Proposals for Urgent Repair Works to the 1830 Warehouse, the Science and Industry Museum, Manchester

Listed Building Consent MCC Ref. 124068/LO/2019

Submission for discharge of Condition 6 (structural timber beams, lintels and joists), 1830 URW

Amendment of a discharged condition – Condition 6

New Drawing - marked-up with location of amended detail for beam end in Bay 1 Basement.

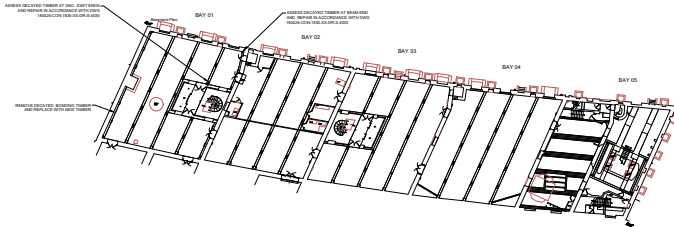
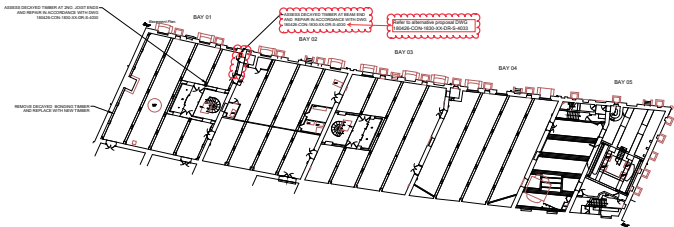
Please refer to the following pages drawings, the new amended plan location drawing shows the location of the detail to change and the change to the detail cross reference to a new drawing; and see also the photograph of the beam to the right of this page. This beam is historic, Baltic pine, and is approximately 3-metres in length. The beam has approximately 200mm of inactive decay at the bearing end which represents a substantial extent of decay which significantly weakens the bearing capacity. A notch created some time in the past to provide headroom to the doorway has reduced the structural capacity of the beam which therefore means that the traditional repair approach would substantially alter the existing beam. Following further investigation and careful assessment by the contractor, structural engineer, architect and heritage consultant in discussion with the client, a proposed repair has been amended based on a detailed survey of the defective fabric and a minimum necessary approach to retain as much fabric as possible.

For avoidance of doubt, the proposed changes to the approved drawings are identified below:

Photograph of existing beam in Bay 1 Basement. The decayed beam end is visible to the left hand side, the existing joint showing the extent of the existing beam is visible to the right hand side.

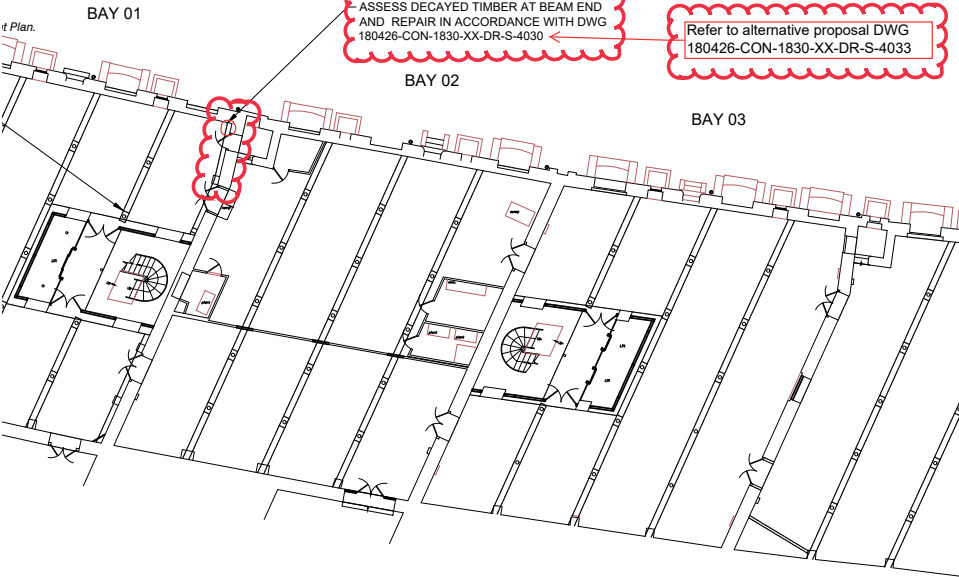
Decayed beam end

Existing notch in beam for existing door

Drawing Status	PRELIMINARY
Project	SCIENCE & INDUSTRY MUSEUM 1830 WAREHOUSE URW
Title	1830 WAREHOUSE (BASEMENT) PRIMARY BEAM REPAIR
Drawing No	180426-CON-1830-XX-DR-S-4033
Date	MAY 2021
Scale	SW
Drawn	SW
Engineer	
Project No	180426
Revision	P1

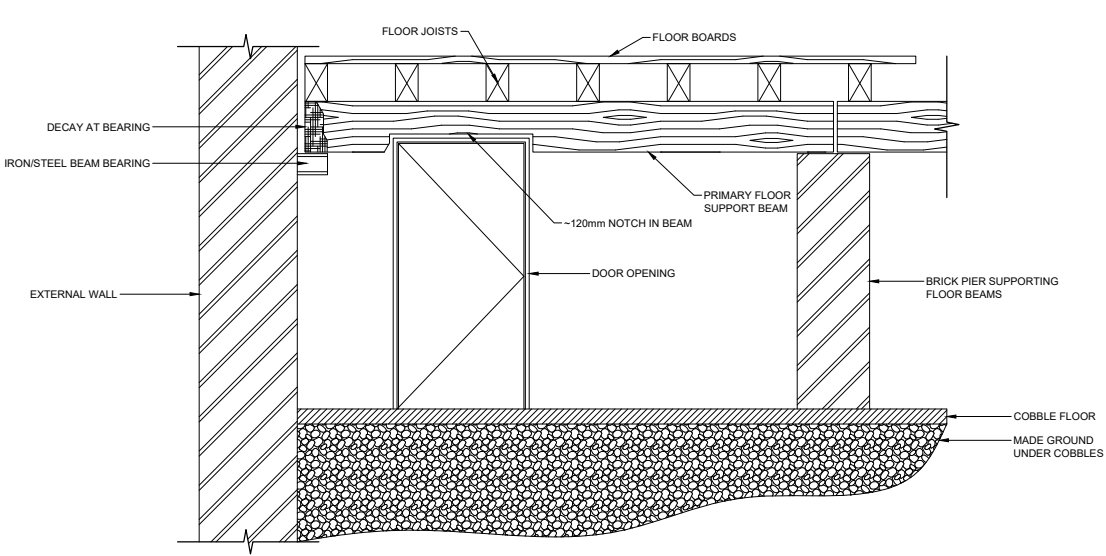
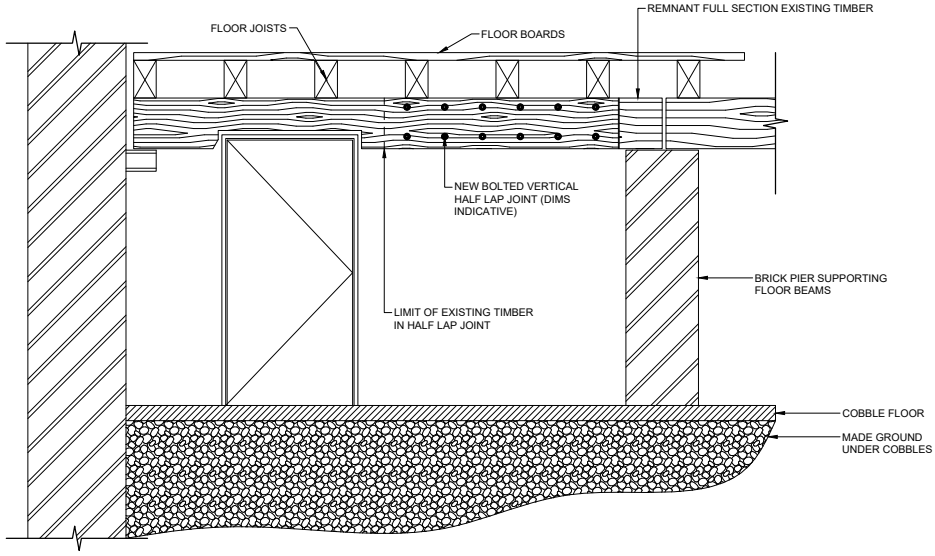
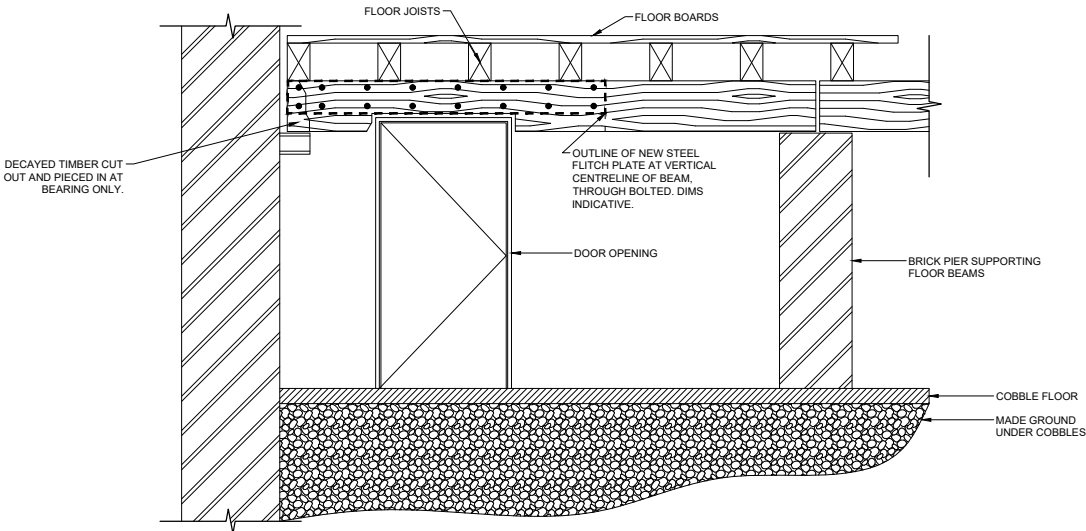
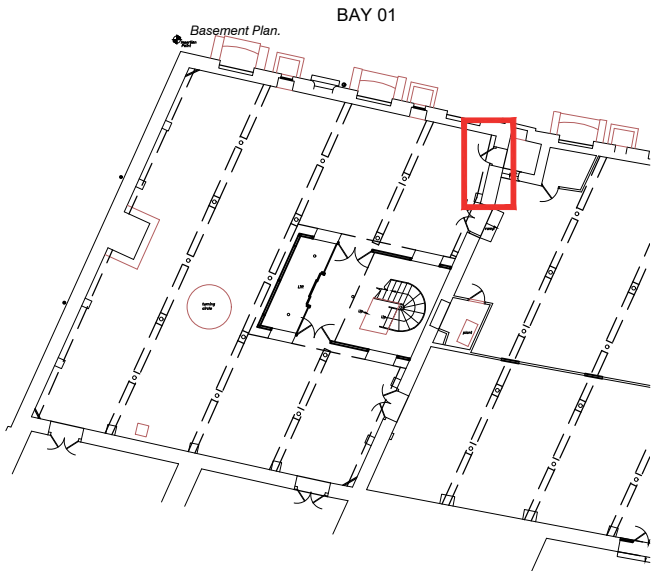
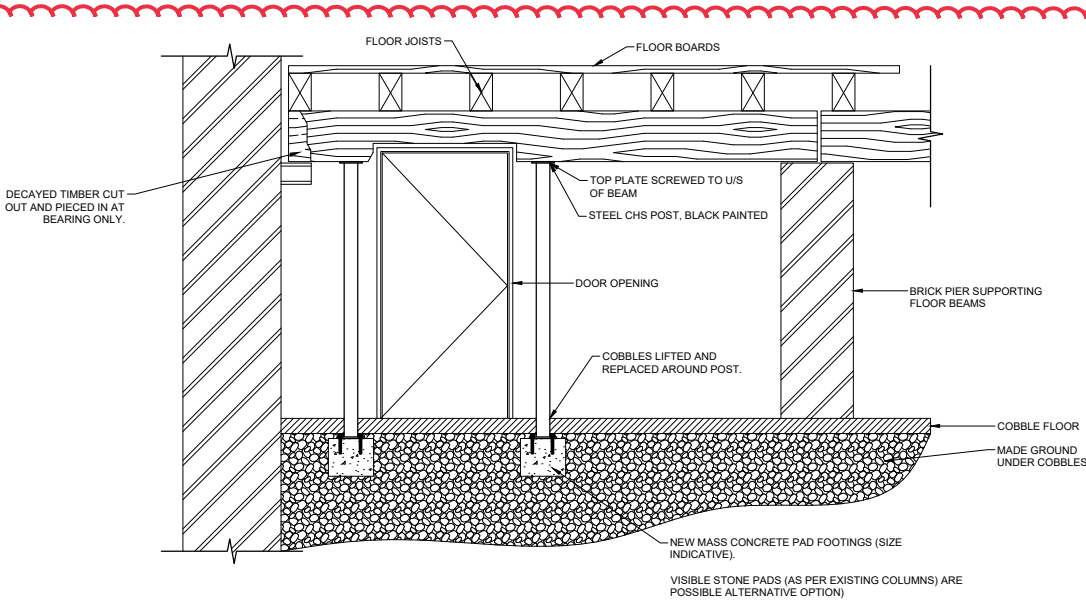
1. HIGHLY INVASIVE - MOST OF HISTORIC BALTIC PINE BEAM IS LOST.
2. DOES NOT ADDRESS LOSS OF STRUCTURAL CAPACITY AT NOTCH
3. COULD REQUIRE BOARD LIFTING AND DEMOUNTING OF M&E EQUIPMENT FOR INSTALLATION ACCESS
4. NOT REVERSIBLE

1. TIMBER AT THE BEAM BEARING IS HEAVILY DECAYED. THE DECAY DOES NOT EXTEND BEYOND THE BEARING AREA (APPROX 200mm LENGTH).
2. THE BEAM HAS BEEN DEEPLY NOTCHED CLOSE TO THE BEARING FOR INSTALLATION OF A DOOR OPENING. THIS HAS REDUCED STRUCTURAL CAPACITY BELOW THAT EXPECTED FOR MUSEUM/GALLERY LOADING.

3. THE CONSENTED REPAIR APPROACH AS PER DR-S-4030 IS TO UNDERTAKE TRADITIONAL BOLTED SPLICE/LAP/SCARF JOINT REPAIRS.
4. IN THIS CASE THE PRESENCE OF THE NOTCH REQUIRES THE GENERIC CONSENTED REPAIR TYPE TO BE LOCATED IN THE FULL DEPTH BEAM SECTION BEYOND.

5. THE FLOOR LOADING NECESSITATES A LONG LAP IN THE REPAIR AND WOULD RESULT IN LOSS OF THE MAJORITY OF THE EXISTING HISTORIC BEAM AND NOT ADDRESS THE LOSS OF CAPACITY CREATED BY THE NOTCH.

6. FROM A CONSERVATION ENGINEERING PERSPECTIVE, AN ALTERNATIVE, LESS INVASIVE APPROACH IS MUCH PREFERRED.
7. ADVANTAGES AND DISADVANTAGES OF THE VARIOUS OPTIONS ARE SET OUT TO THE LEFT ADJACENT TO THE SKETCHES.

1. DIFFICULT TO INSTALL - ACCESS FOR BOLTING IS VERY RESTRICTED
2. COULD REQUIRE BOARD LIFTING AND DEMOUNTING OF M&E EQUIPMENT FOR INSTALLATION ACCESS
3. NOT FULLY REVERSIBLE

The drawing 180426-CON-1830-XX-DR-S-4033 illustrates two repair options. Repair Option 1 could require further lifting of floor boards to gain adequate access. Repair Option 2 is preferred as it provides a permanent solution with two minimal steel posts either side of the doorway which will bolt into the existing beam, two small footings below the cobble and only a small number of existing cobbles to be set aside.

Repair Option 2 was discussed on site and agreed in principle on 27/05/21 with Paul Mason.

8. OUR PREFERENCE WOULD BE OPTION 2 TO INSTALL SUPPORT POSTS AS THIS HAS MINIMAL IMPACT ON EXISTING HISTORIC FABRIC IN THE TEMPORARY AND PERMANENT CONDITIONS, AND IS FULLY REVERSIBLE SHOULD THE NEED EVER ARISE.

1. MINIMAL HISTORIC TIMBER LOSS
2. NO CHANGE IN APPEARANCE OF BEAM
3. ADDRESSES LOSS OF STRUCTURAL CAPACITY AT NOTCH
4. POSTS HAVE VISUAL SIMILARITY TO EXISTING COLUMNS
5. FULLY REVERSIBLE, NO SIGNIFICANT CHANGE TO COBBLES OR TIMBER.
